Your Ref.: A/NE-TKLN/108

Our Ref.: 25/864/L02

**Temporary Vehicle Park for Crane Lorries and Associated Filling of Land for
a Period of 3 Years in “Agriculture” Zone, Lots 768 and 769 in DD78,
Ta Kwu Ling, New Territories
(Application No.: A/NE-TKLN/108)**

Responses to Departmental Comments

Photo of the existing nullah

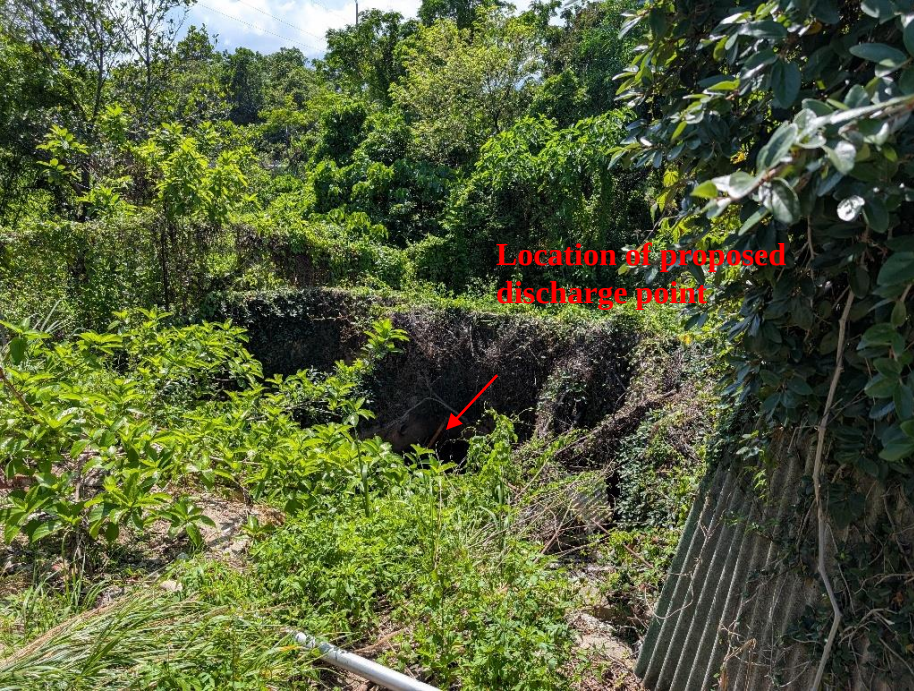
Departmental Comments	Responses
- There is no formal record of the so-called “existing watercourse” to which the proposed drainage system to be connected. The applicant is required to provide evidence to demonstrate its presence (e.g. photos with a plan showing the locations of the camera and directions of all photos taken) and details of the watercourse (e.g. dimensions).	The existing watercourse is shown in the following aerial photo extracted from Open3Dhk of the Lands Department.  The image is a screenshot of the Open3Dhk web application. It displays an aerial view of a rural area with green fields and some buildings. Two features are highlighted with red arrows and labels: 'Existing Nullah' (a small stream or ditch) and 'Existing Watercourse' (a larger, more defined channel). The interface includes a search bar at the top left and navigation controls at the bottom right.

More photos of the existing watercourse can be presented in a revised drainage proposal if so required.
